## DOCUMENT CHANGE REQUEST

DCR number	593	Changes required for:	General	Originator:	Jean-Laurent BOUTEAUX
Date:	2010/04/21	Date sent:	2010/04/21	Organisation:	CNES
Status:	IMPLEMENTED

Title: Connectors Miniature Electrical Circular Triple-Start Self-Locking Coupling Scoop-Proof Hermetic

Number: 3401/057 Issue: 2

**FIGURE 2(b) – SPECIAL CONTACT ARRANGEMENTS – FRONT VIEW MALE INSERT (3)**

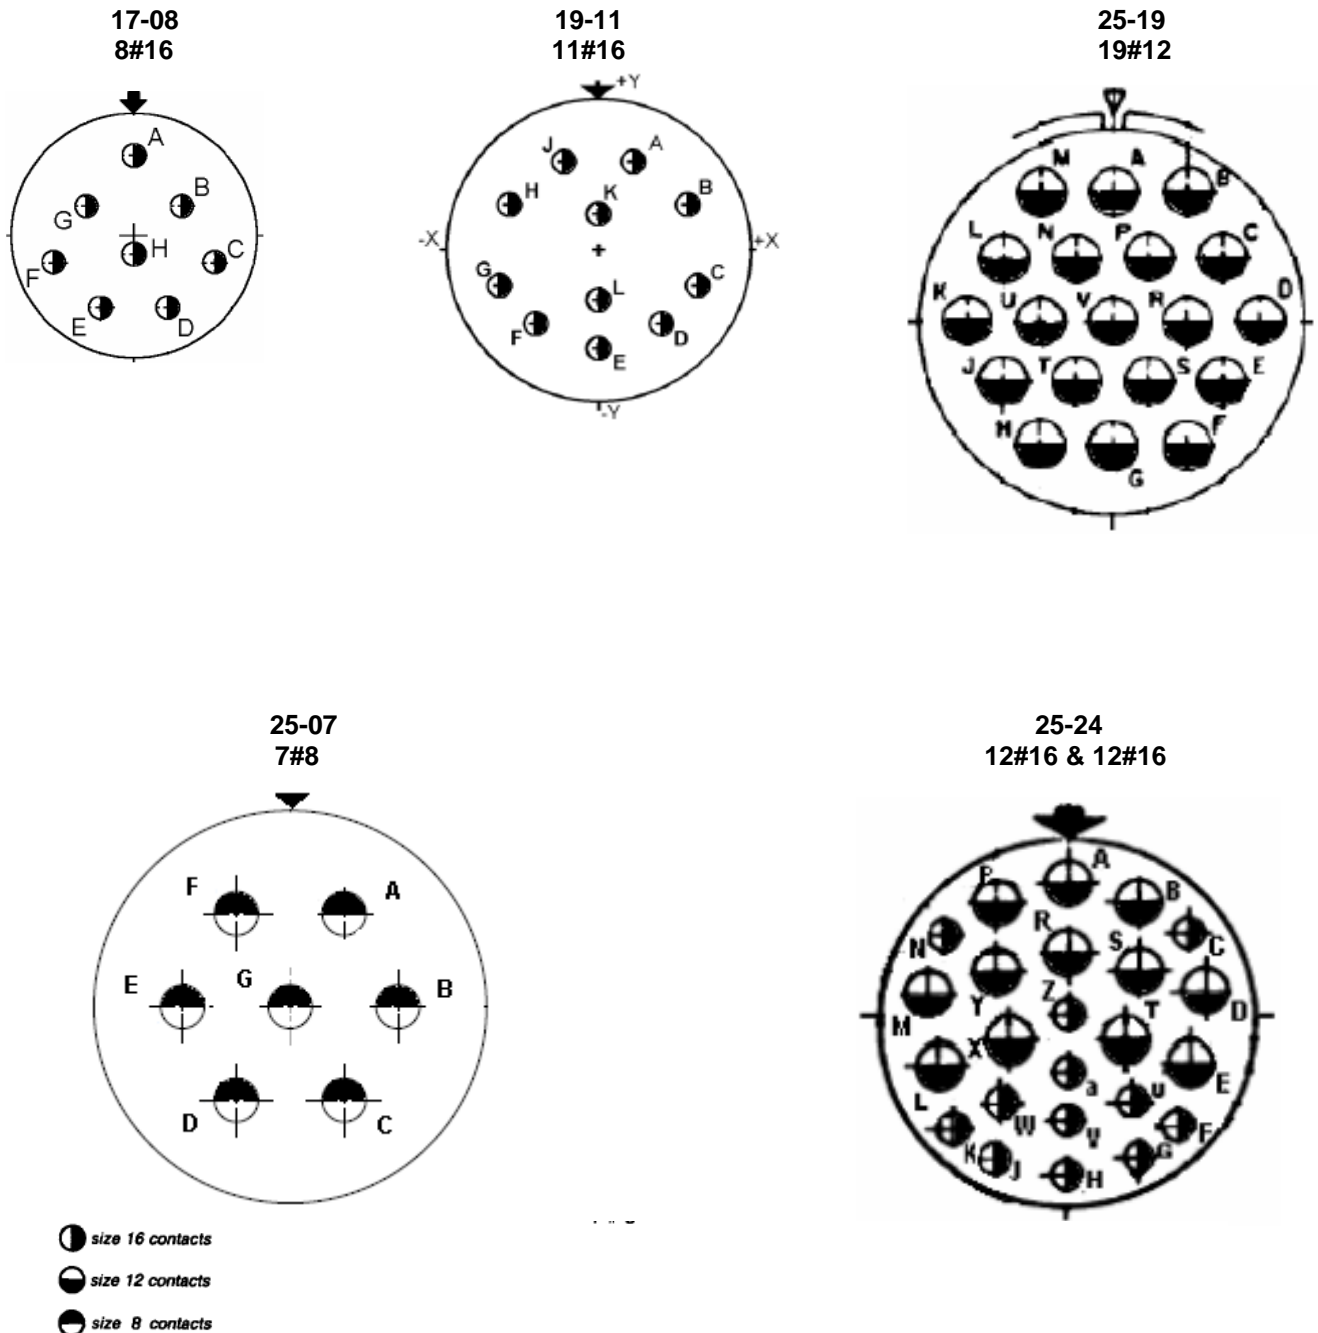
Page 13 "Special contact arrangements"  
Add 25-24 (12 #16 & 12 #12)  
Page 19 Â§ 4.5.4.3 Contact arrangements  
Add 25-24 Service Rating II

Extension of the contact arrangements range available further a customer request.  
Contacts size 16 are already qualified in arrangements 17-08 and 19-11, contacts size 12 in the arrangement 25-24. In the next maintenance of qualification, there will be samples with 25-24 arrangement.

The attachment (page 13) to be corrected:

25-24 arrangement

It should read:

25-24

12 #12 & 12 #16
